SABERTOOTH CRAMPON & TOURING BRACKET REPLACEMENT PROGRAM

At Spark R&D we're always working on ways to improve our products, and your time in the backcountry. We've gone through a number of versions of crampons and touring brackets since first introducing our Tesla bindings for the 2013/14 season. Our latest versions are a significant improvement over the initial versions we've released, so we are replacing the older ones for free. Check your crampons and brackets against the images below. If either are eligible for replacement please follow the return information at the bottom.

Crampon Version 1

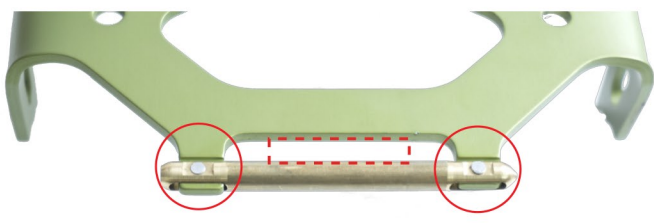
Large brass rivets, no center tab - Will be replaced with V4 Crampons.

Crampon Version 4

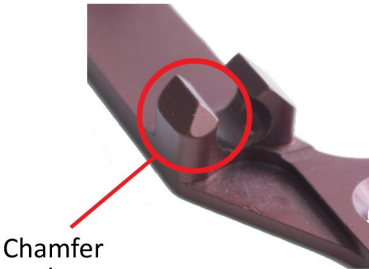
Center tab remains with addition of two more rivets. Upcoming 2015/16 version.
